Official Recall Notification United States Federal Boat Safety Act Throttle Linkage Rod Replacement

Models Covered	Serial Number Or Year
225 V-6 EFI FourStroke	0T653945 through 1B055871

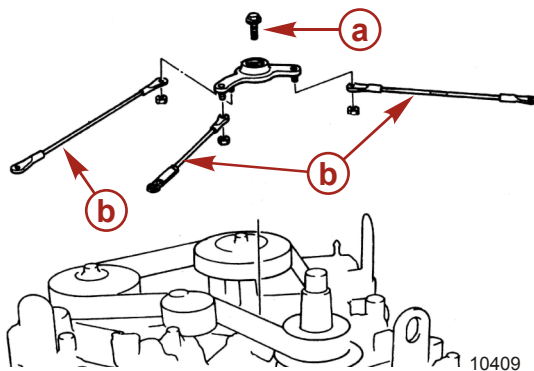
The engines identified above are at risk for throttle sticking. This risk exists even if the repair work from service bulletin 2003-09 has already been performed. As with the previous service bulletin, this failure could result in the engine not returning all the way to idle after running at an elevated RPM level, in either forward or reverse, when pulling the remote control throttle lever back to the neutral position. This may cause the engine to stay at a fast idle speed (1200-2000 RPM), which may prevent the operator from disengaging the shift mechanism and shifting into neutral.

A replacement Link Rod Kit (888603A01) is required. This kit contains updated link rods that have been improved to prevent sticking in the ball joint area of the link rods.

- a - Bolt with washer
- b - Link rods

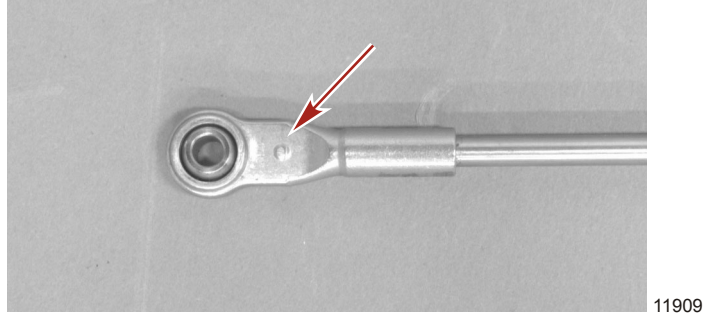
- The link rods must be assembled with the identification mark (raised dot on the link joint) facing up.

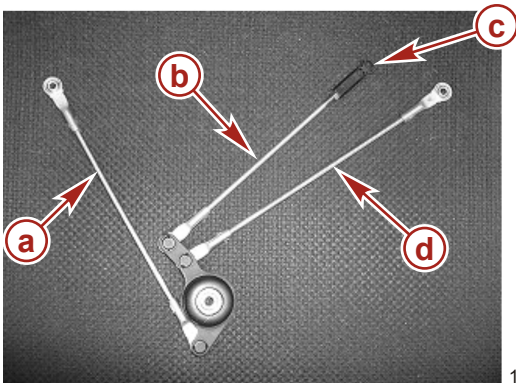
- Assemble new link rods to the accelerator arm assembly as shown below.

- a** - Port throttle body link rod (shorter rod)
- b** - Link rod assembly attaching to control lever
- c** - Retained link and locknut
- d** - Starboard throttle body link rod (longer rod)

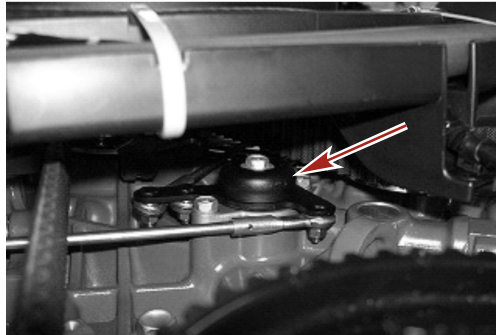
- Reinstall the accelerator arm assembly on the engine. Be sure to use the new bolt and washer supplied with this kit. Torque the bolt to specification.

Description	Nm	lb. in.	lb. ft.
Bolt	8		5.9
